Alert 05-09

INADVERTENT DISCHARGES OF MARINE FIRE EXTINGUISHING SYSTEMS

Bulletin No. 5559

DATE: July 16, 2009
TO: Authorized ANSUL® Marine High Pressure Carbon Dioxide System Distributors
FROM: Quality Assurance
SUBJECT: Inadvertent Discharges of Marine High Pressure Carbon Dioxide Systems

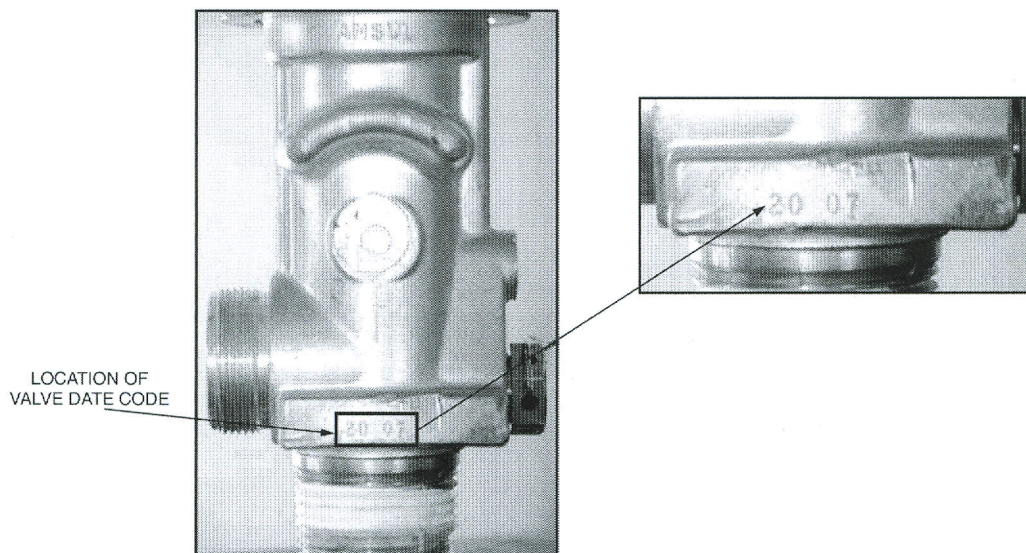
We have received isolated reports of Marine High Pressure Carbon Dioxide Systems inadvertently discharging. In our review of the reported discharges, we have discovered that in some cases, an internal pressure vent on the cylinder valve may not be adequately venting pressure. Under certain conditions this may cause a cylinder in the system to actuate, which would then cause all cylinders on this specific system to actuate.

We have determined through internal testing that valves with the following date codes, if installed in marine applications, should be replaced:

Marine High Pressure CO₂ valves with a date code range of 10-07 to 06-08.

This date code range is conservative and may be further narrowed through additional testing. The date code is located on the flat opposite of the valve outlet. The date code represents the week and year the valve was manufactured.

Carbon dioxide cylinders which are installed, or could be installed on a ship with a valve date code between 10-07 and 06-08 **MUST** be identified. If you identify cylinders with valves in this date code range, please contact ANSUL Quality Assurance **IMMEDIATELY** for further information and authorization for replacement of these cylinders.
